SUBJECT: Kit A-12958 to make 350 Chain Saw Carburetors
 HDC-16 and HDC-21 fully adjustable for altitude
 conditions.

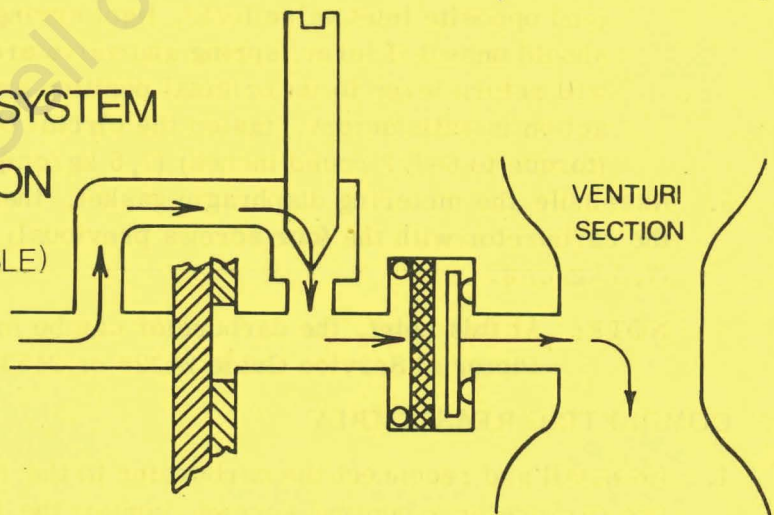
HI SPEED SYSTEM OF CARBURETOR BEFORE MODIFICATION

PORTION OF HI SPEED SYSTEM AFTER MODIFICATION

(NOW FULLY ADJUSTABLE)

The HDC-16 and HDC-21 carburetors supplied as original equipment are identical except for the diameter of the fixed high speed jet (fuel take-off) holes in their circuit plates. Both of these circuit plates may supply too much fuel for proper operation at high altitudes. To assure proper operation at high altitudes this kit has been made available. The kit contains a gasket and a circuit plate without a fixed jet hole. It also contains sheet #24907 for instructions on correct adjustment of the modified carburetors, plus a triangular label which is to be put on the outside of the air filter cover so the owner will know that the carburetor is adjustable. With this blank circuit plate installed, all of the fuel will flow through the bypass channel and be metered by the HI SPEED NEEDLE (see drawings). The carburetor adjustment Instruction Sheet #24907, should be given to the saw owner.

1. Remove four cover screws and the metering diaphragm cover. Carefully lift out the diaphragm and diaphragm gasket. Two flat head screws hold down the circuit plate. The fulcrum pin of the circuit plate holds the inlet needle, lever and lever spring assembly in position. Remove the two screws. Remove and discard the circuit plate and the gasket. Drop the inlet needle valve back into the valve seat if it came out during disassembly.

2. Using the gasket #67367-A and circuit plate #67382 from Kit A-12958, assemble as follows:
 - a) Drop the lever spring into the spring recess in the carburetor body. Position gasket in the chamber. Fit the lever under the fulcrum pin of the new circuit plate.

- b) Simultaneously, engage the lever spring on the dimple of the lever and slide fork of lever onto the needle while installing the new circuit plate #67382.

- c) Hold down the plate and check lever/spring action. While pressing down on lever (end opposite inlet valve fork), light spring resistance should be felt and inlet valve should unseat if lever, spring and valve are installed properly. Release of the lever will return lever to its original position and seat the inlet valve. If the lever/spring action is satisfactory, fasten the circuit plate in place with the two flat head screws (torque to 6-1/2 pound inches) (7,5 kg/cm).

SUBJECT: Correct Engine Speed Adjustment of Kohler K91J
 Engine of PCS-30 Compactor is Essential for Good
 Soil Compaction

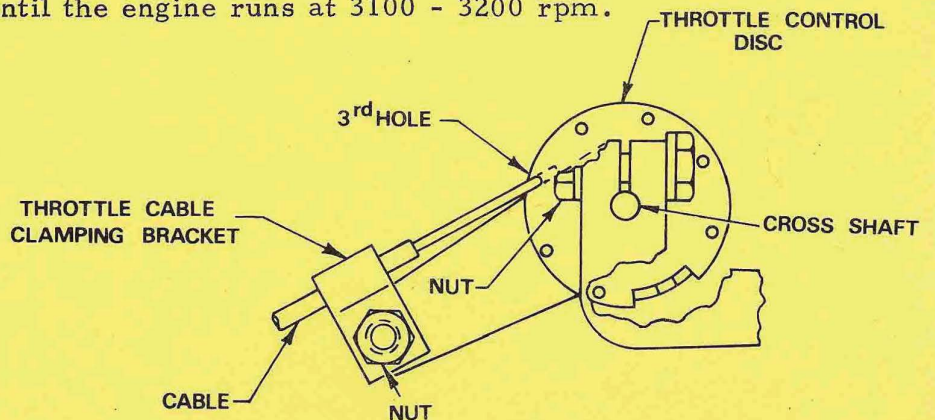
The engine speed should be set to 3100 - 3200 with the aid of a tachometer. Before doing this, be sure to check the throttle control for proper assembly and action. Referring to the drawing, proceed as follows:

1. The screw and nut in the throttle cable clamping bracket should have the screw head on the inside and nut on the outside. If installed in the reverse, remove and reinstall properly.

2. Check that the throttle cable is hooked into the third hole clockwise from the cutout in the throttle control disc.
3. Check that the throttle cable is clamped in a position in which the cable wire can fully open and close the throttle. If the cable was clamped too shortly for full travel, loosen the bracket clamp. Then reposition the cable in the clamp, as required, and reclamp it.

4. Start the engine and check the full throttle speed with a tachometer. The full throttle speed should be 3100 - 3200 rpm. If the engine is not running within this speed range stop the engine and proceed as follows:

- a. Put the throttle control handle to the full throttle position.
 - b. Loosen (but do not remove) the nut which holds the governor arm to the throttle cross shaft.

- c. Using pliers, rotate the throttle cross shaft as required -- clockwise to decrease, counterclockwise to increase speed.
 - d. Tighten the nut to lock the governor arm to the cross shaft. Start engine and check speed with a tachometer. Repeat steps a) through d) if required, until the engine runs at 3100 - 3200 rpm.

E. Procedure to update older units to the new system. (SEE SCHEMATIC)

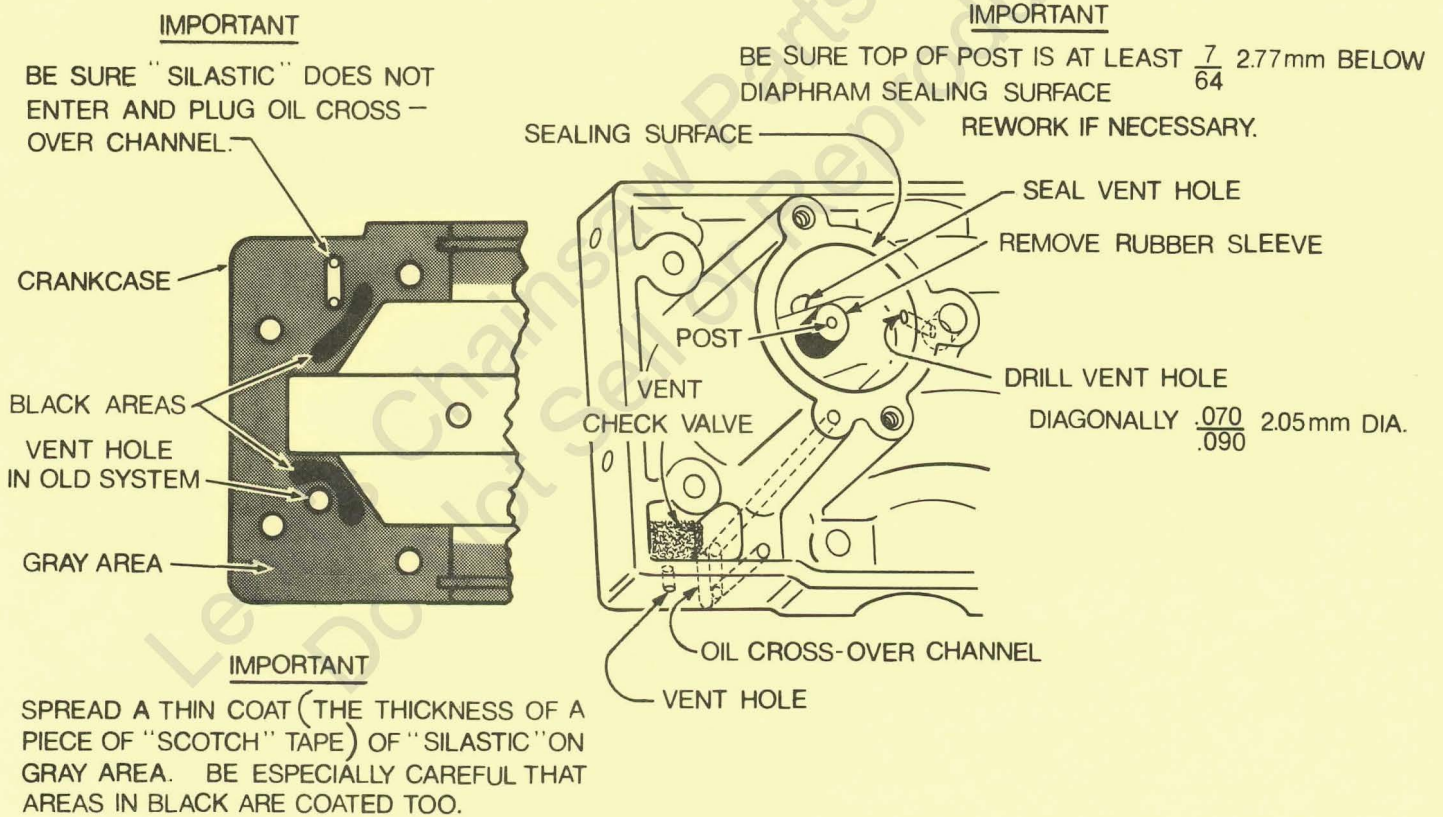
1. Drilled vent hole from diaphragm chamber thru cylinder flange eliminated.
2. Cast slot added to crankcase, to vent diaphragm chamber (dry side) into pulse hole for oil pump.
3. Felt filter in crankcase vent passage eliminated.

4. Rubber sleeve #68617 eliminated.
5. Post for rubber sleeve eliminated.

1. Disassemble oil tank and oil pump.
 2. Remove rubber sleeve #68617 that was bonded to post.
 - * 3. Seal vent in (dry side) diaphragm chamber with R.T.V. silastic (part #24823). Clean hole of oil for good adhesion.
 - * 4. Drill vent hole (.070/.090 dia.) from dry side of diaphragm chamber, diagonally into pulse hole for oil pump. (see schematic) Use extreme care to keep drill chips out of crankcase. Remove crankcase if necessary.
 5. Replace plunger A-68583-A (.010 thick dia.) with A-68583-B (.025 thick dia.) and eliminate gasket #68650-A (2).
- * Items #3 & 4 may be omitted providing the original vent hole is open to atmosphere, however, with these omitted the oil pump will pump oil at idle.

NOTE: Check mating surfaces of oil pump and crankcase to assure they are smooth and flat. Roughness or out of flat condition may be corrected by rubbing a few strokes over #180 grit emery paper on a flat surface plate.

6. Replace oil pump and plunger and pressure test through oil inlet line at 8-10 psi. Inlet line and pump must be full of oil when testing.

TO: All Districts, Branches and Chain Saw Dealers
SUBJECT: Starter Rope Grip W/Insert and Cap #A-69962 **DATE:** 12/74
USAGE: Chain Saws, Pumps, Power Tools

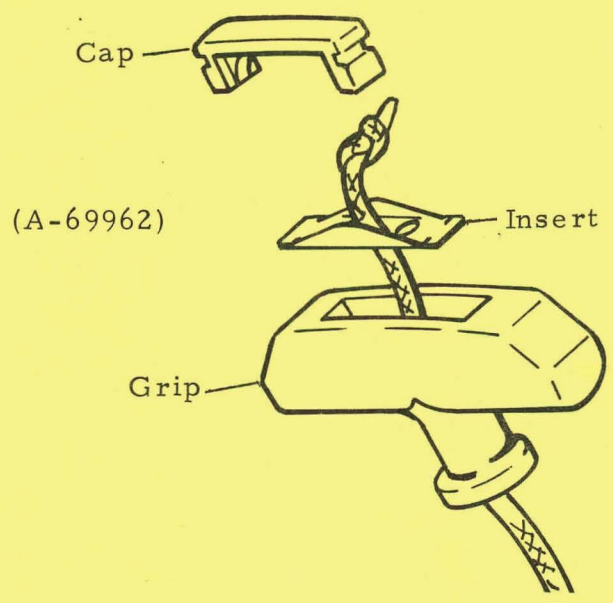
A new starter rope grip with insert and cap #A-69962 is available for service use.

This new three piece assembly includes a grip, insert #12649 and cap #12782. Grip #12624 will no longer be supplied separately, as it is now part of A-69962 assembly.

A-69962 Starter Rope Grip w/Insert and Cap supersedes:

The new parts of the three piece starter rope grip assembly are not individually interchangeable with the old two piece type. They can only be used as two or three piece sets.
